AGENDA

PLANNING AND ZONING COMMISSION

JANUARY 16, 2020

RATLIFF RIDGE, 4th FILING,
An Addition to the City of Odessa,
Being a Subdivision of 29.95 Acres of Land in Section 35, Block 42, T-1-S, T&P RR Co. Survey, Ector County, Texas

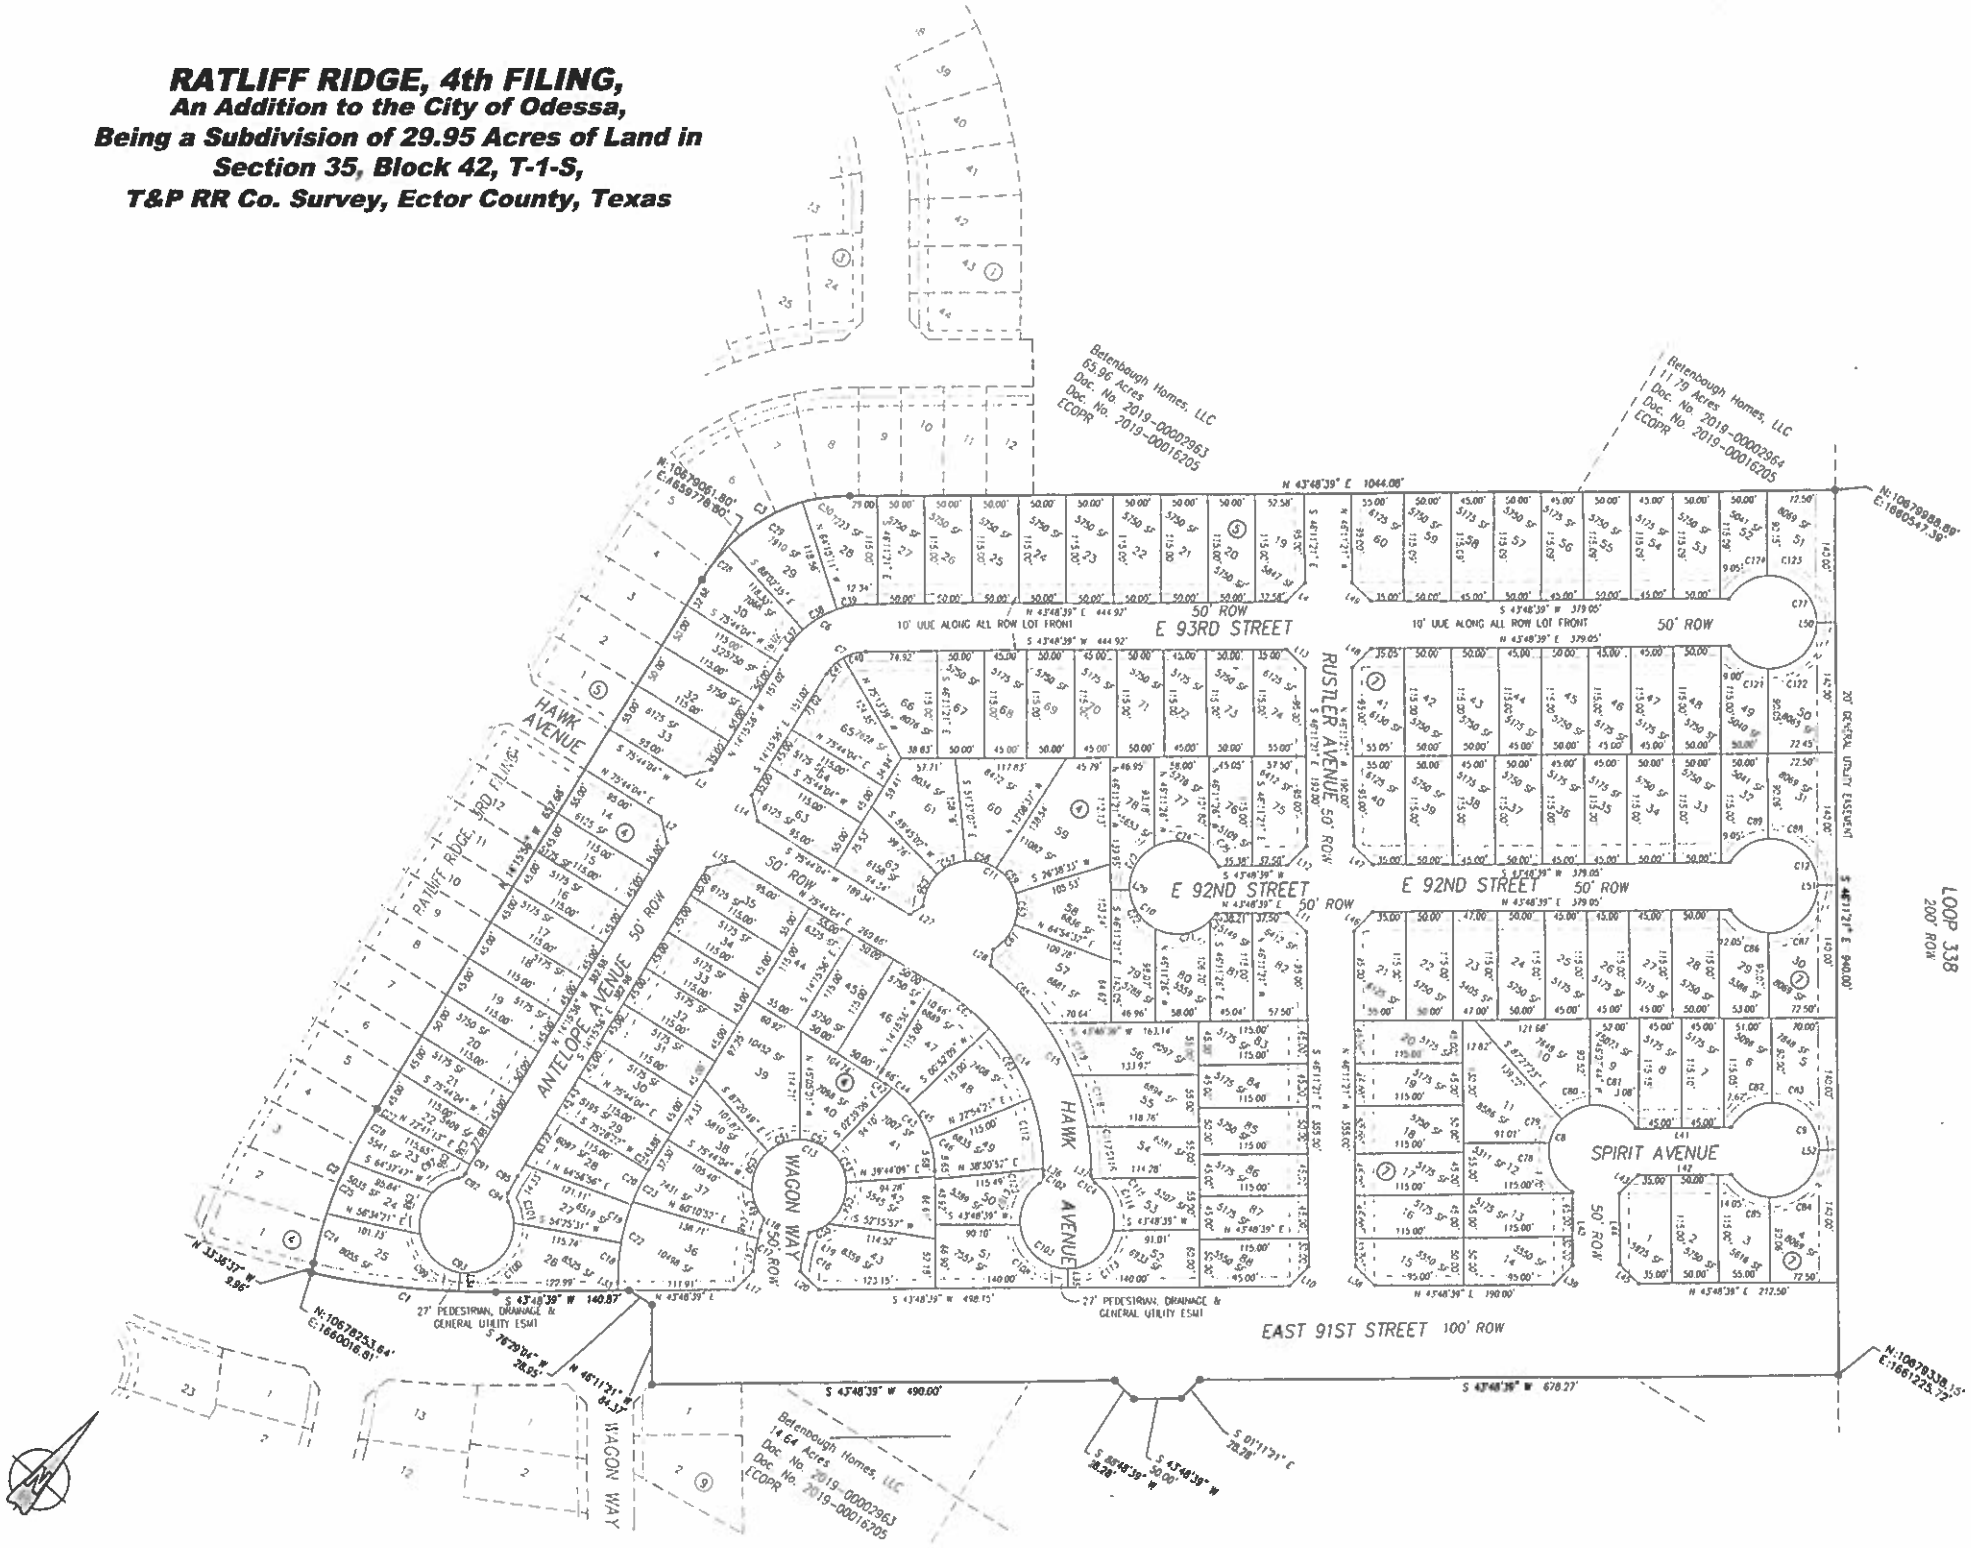
-- A blanket refuse collection easement is noted on the plat.

-- Pedestrian easements connecting cul-de-sacs at Antelope Ave. and Hawk Ave with 91st St. are noted.

-- Ownership and original tax certificates need to be submitted prior to filing the plat.

-- Administrative site plan approval is required prior to development.

-- Water and sewer are available for extension. No pro rata is due.

-- Drainage report needs to be submitted. This tract is not in a special flood hazard area.

-- Show all appropriate utility and drainage easements.

-- Water, sewer, paving and drainage plans need to be submitted for review and acceptance.

-- If drainage from this plat is towards LP 338, post-development drainage/runoff should not be changed/increased from pre-existing conditions. (TxDOT)

-- An Improvements Agreement will be required.

-- Any work in the right of way or easements will require a permit from the Engineering Division and must comply with current City Ordinances and policies.

WINWOOD ADDITION
7TH FILING

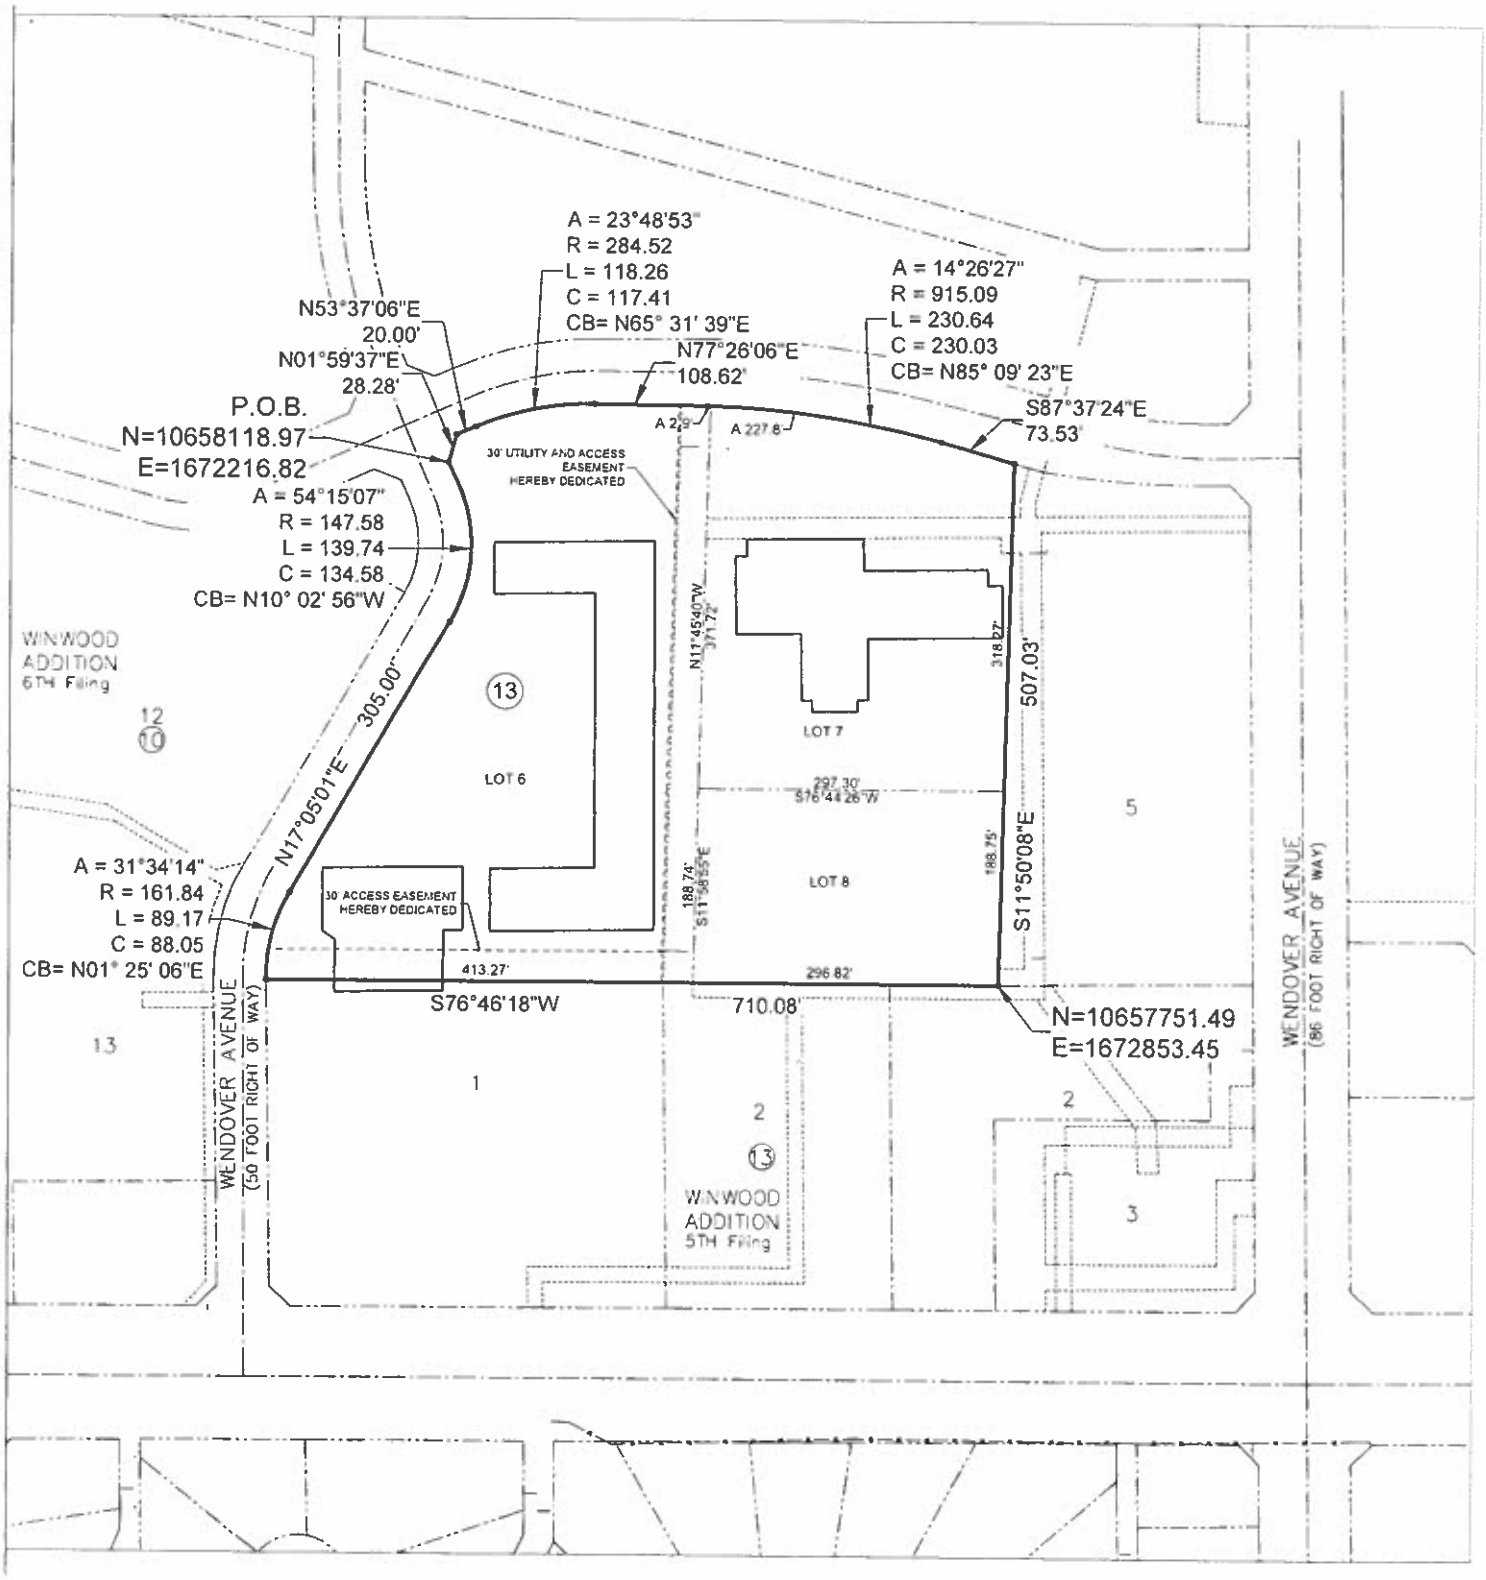
-- Original tax certificates needed prior to filing the plat.

-- A blanket refuse collection easement is needed on the plat.

-- Utility and access easements shown on the plat need to be dimensioned.

-- Ghost lines of existing buildings will not be necessary on the filed plat.

-- Signature blocks for Director of Public Works and Director of Planning need to read "for Director of Public Works" and "Director of Development" respectively.

-- Drainage report needs to be submitted.

-- Lot 8 does not have street frontage. Access is from access easements.

1. Mylar will not be filed until the access easements are cleared of obstructions. (Public Works/Planning)

2. A Blanket Refuse Collection Easement Agreement will be required. (Public Works/Planning)

FAUDREE ROAD DEVELOPMENT 5TH FILING

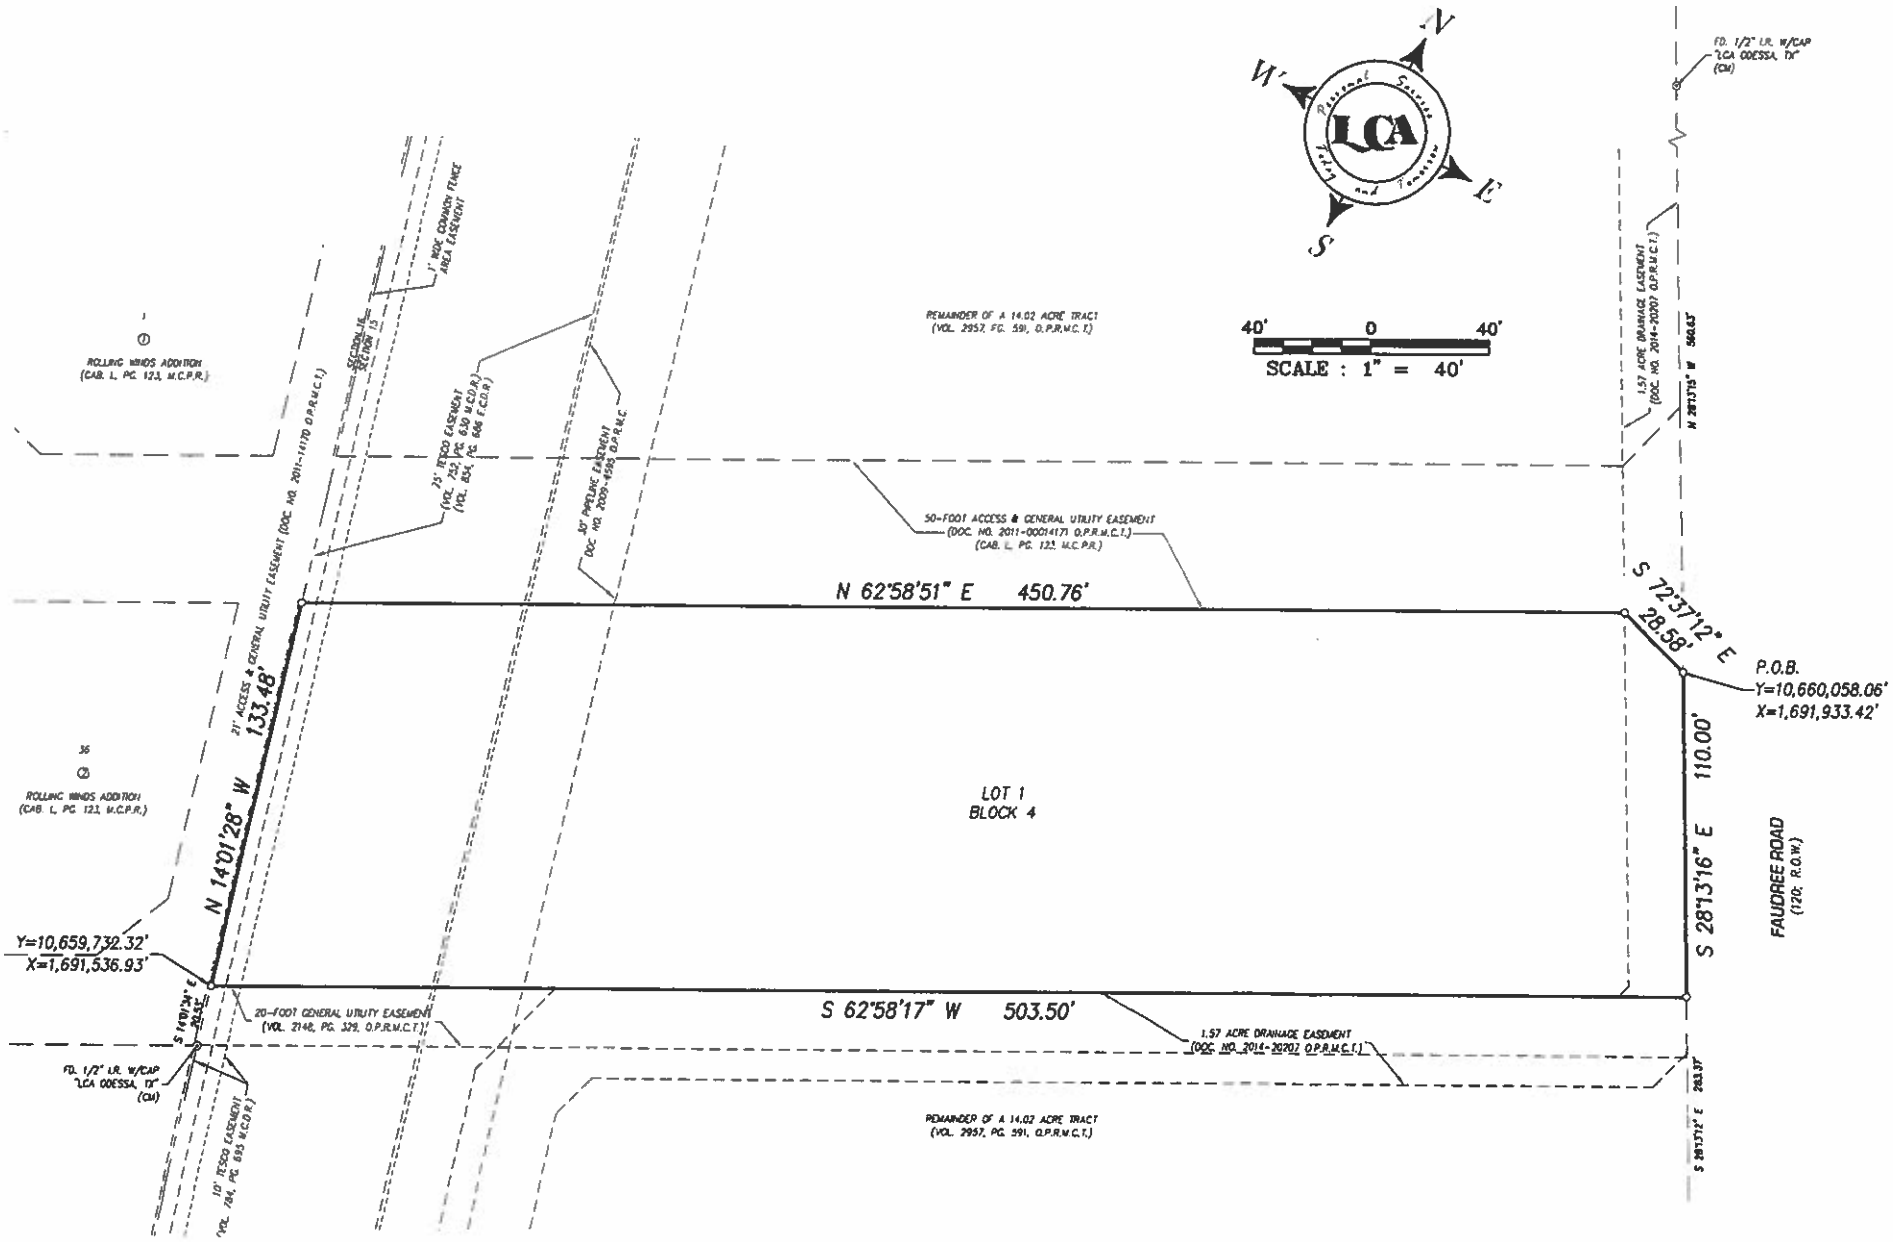
-- Ownership certificates and original tax certificates needed prior to filing the plat.

-- Various easements noted on the plat need to be dimensioned.

-- Drainage report needs to be submitted. This tract is not in a special flood hazard area.

-- A Blanket Refuse Collection Easement Agreement will be required.

1. Add a note to the plat: No direct access to Faudree Road from Lot 1, Block 4 is allowed. (City of Odessa Public Works)

2. Access should only be allowed to what is being shown as public street (Rolling Winds Circle). No additional access to Faudree should be allowed. Post-development runoff should not be increased from pre-development conditions. (TxDOT)

REPLAT OF LOT 4, BLOCK 7,
WESTMOOR ACRES
2.03 ACRES IN SECTION 14, BLOCK 43, T-2-S, T&P RY. CO. SURVEY, ECTOR COUNTY, TEXAS

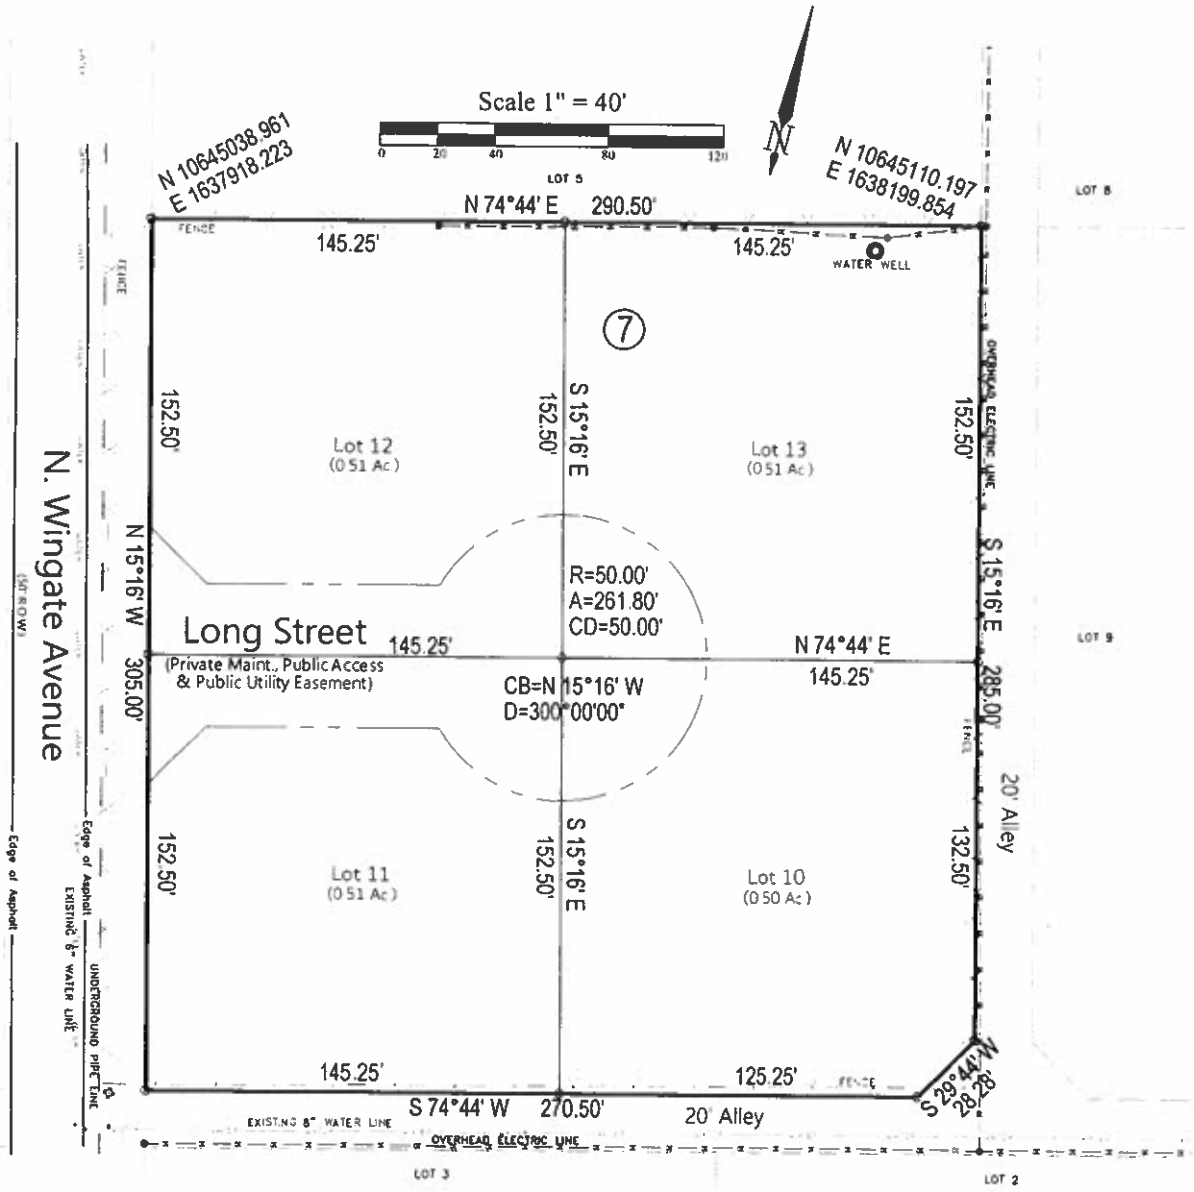
-- Original tax certificates are needed prior to filing the plat.

-- Drainage report needs to be submitted. This tract is not in a special flood hazard area.

1. Long Street has a direct conflict in street name with Long Avenue located in Ector County. Recommendation is for consideration to be given to assign a new street name to avoid any potential confusion for emergency response teams. (ECDEC))
